MX13 Block Top Fit Liner

PACCAR POWERTRAIN

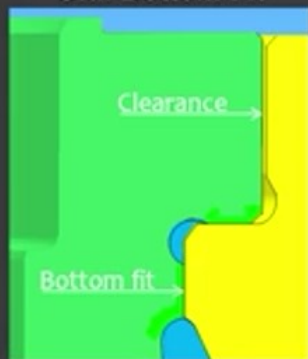
The issue is fretting fatigue damage at the balconies. This problem is predominantly with NA17 HE500.

Change liner fixation design from "bottom fit" to "top fit". This will reduce relative movement between the bloc (balcony) and liners (collar) at the contact interfaces. Simultaneously multiple minor machining changes in the block are implemented for backwards compatibility with MY2021 (see presentation).

Old: Bottom Fit

New: Top fit

Old/New PN Block: 2115212 / 2237717

Old/New PN Liner: 1856324 / 2143815
